TO: MR DAVID CROXTON FILE COPY
HW - 106 ENFORCEMENT
SENSITIVE
FROM: ROBERT Farrell

Draft letter

USEPA RCRA

CASE I - using Hart/Crowse's Elevation for the top of grid on boring log and their description of the sediments

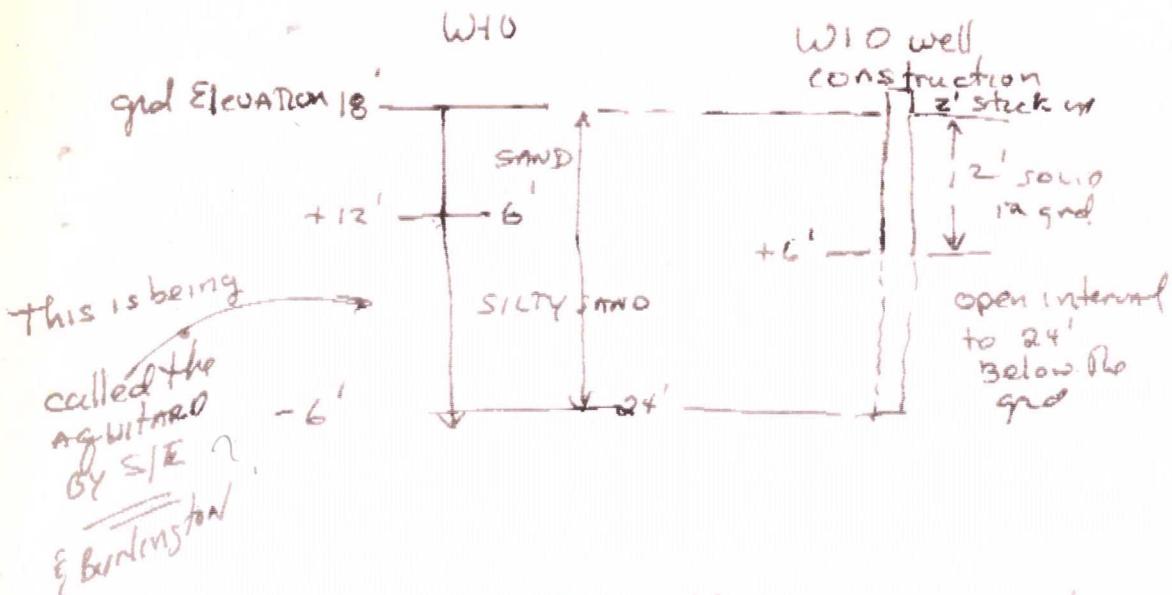
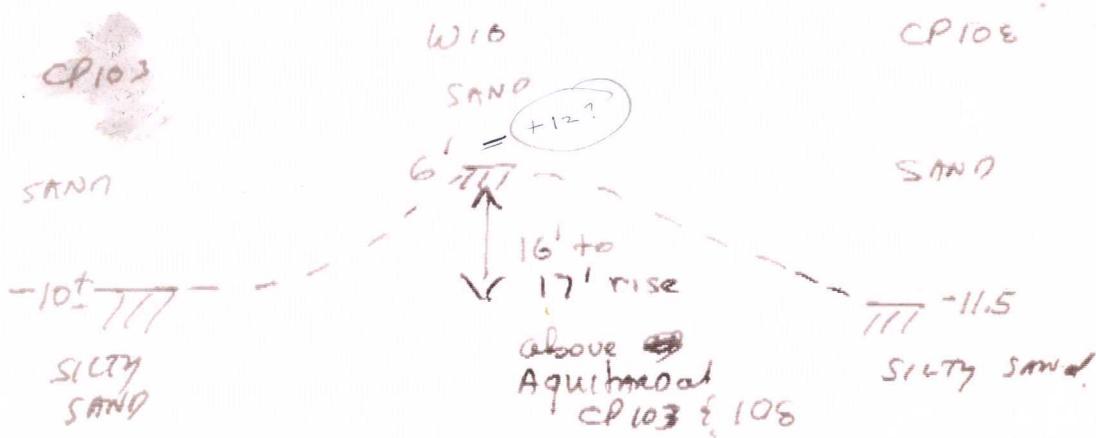
Putting this in cross section with CP103 & 108

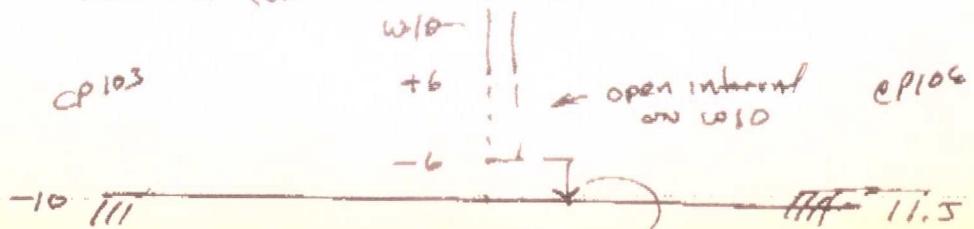
However, if we assume Hart/Crowse's description are in error but the grid elevation is correct AND we project the aquitard surface from CP103 to CP108

Bottom of screen would be 4-5' above projected elevation at ± 10.5

CASE II

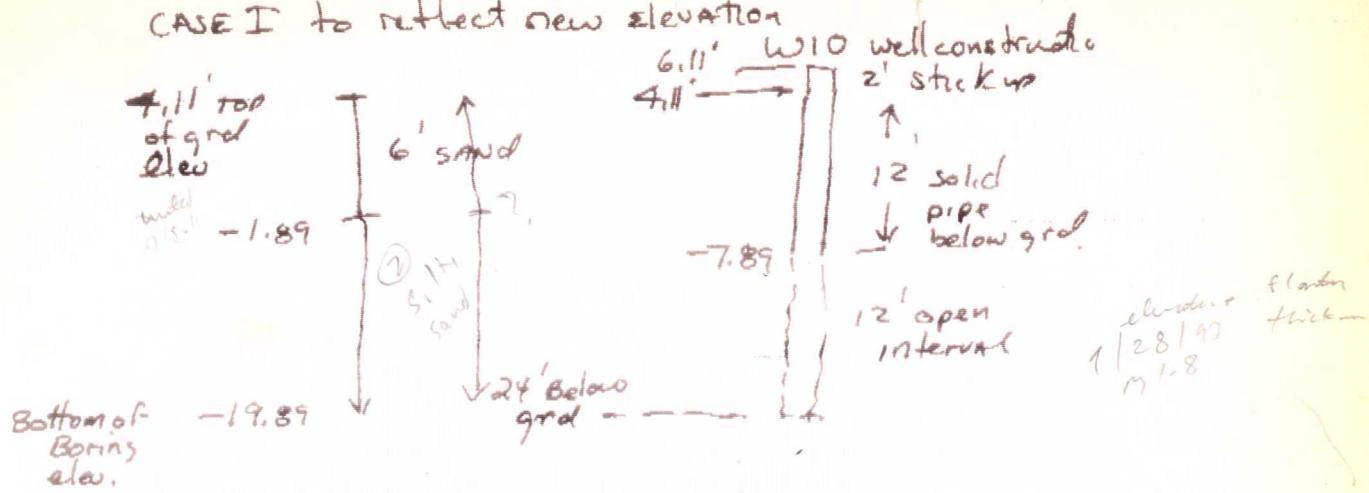
use S/E elevation for
the measuring point of
6.11' instead of 18'
m.p. elevation

modify the elevations shown in

CASE I to reflect new elevation

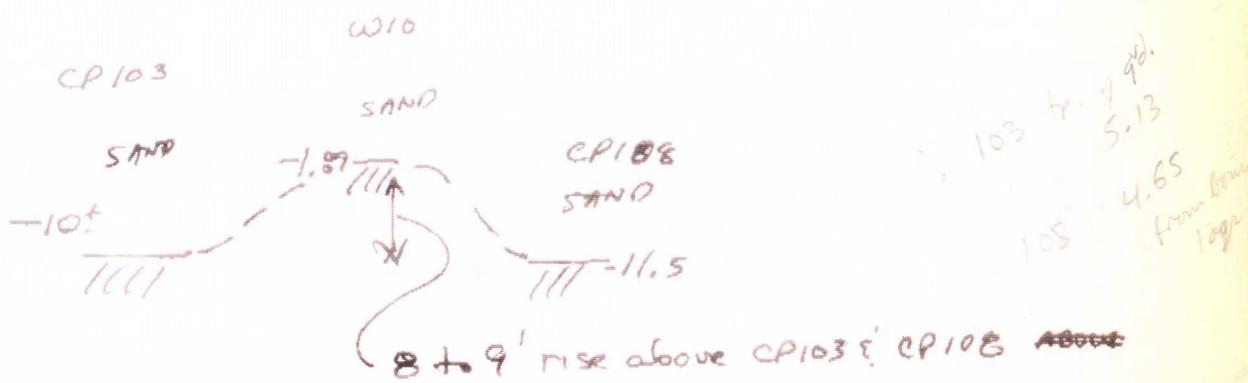
Putting new elevations for boring log in cross section with
CP103 & 108

However if we assume H/C description is incorrect, and project the elevation of the aquitard at W10 from CP103 & 108
